San Ramon Valley Unified School District

Addendum/Clarification No. 1 **Item Bid: Seal Coating & Localized Pavement Repair at Various Sites** **RFB# 774**

CORRECTION: Page 42, Asphalt Projects Summer 2018.

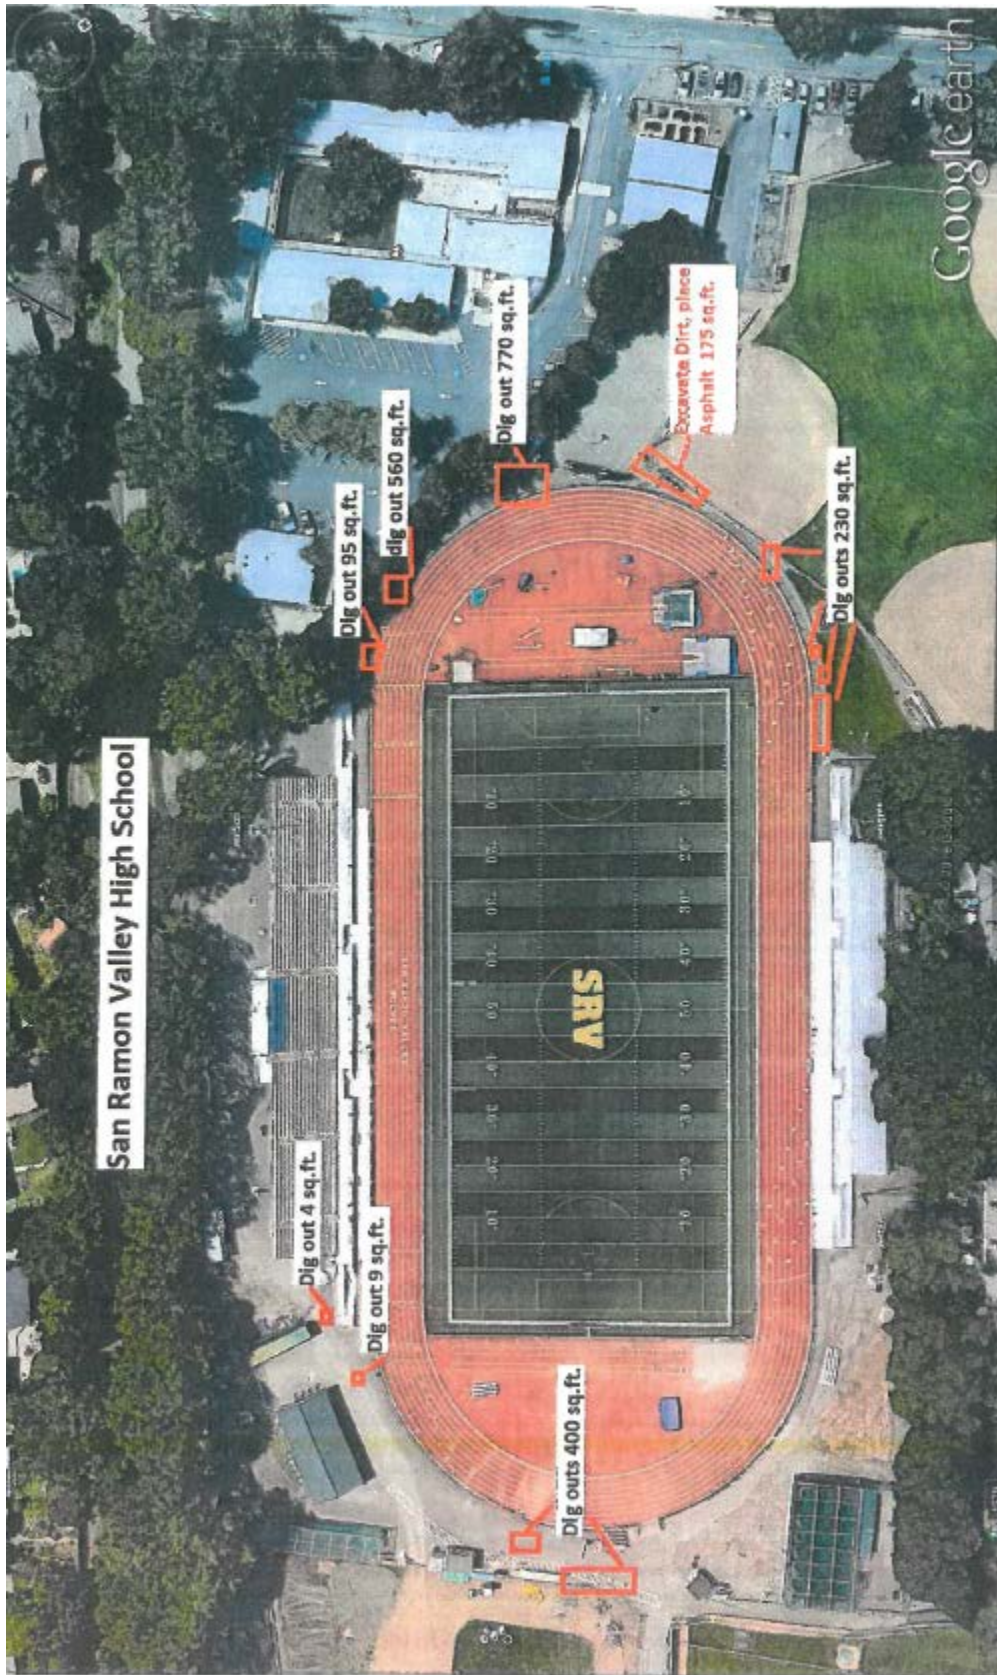
(See revised maps for Neil Armstrong, San Ramon Valley, Monte Vista below)

Area F Change scope from
Digouts/Crackfill/Seal coat to
Remove/Replace 20,557 sq.ft.
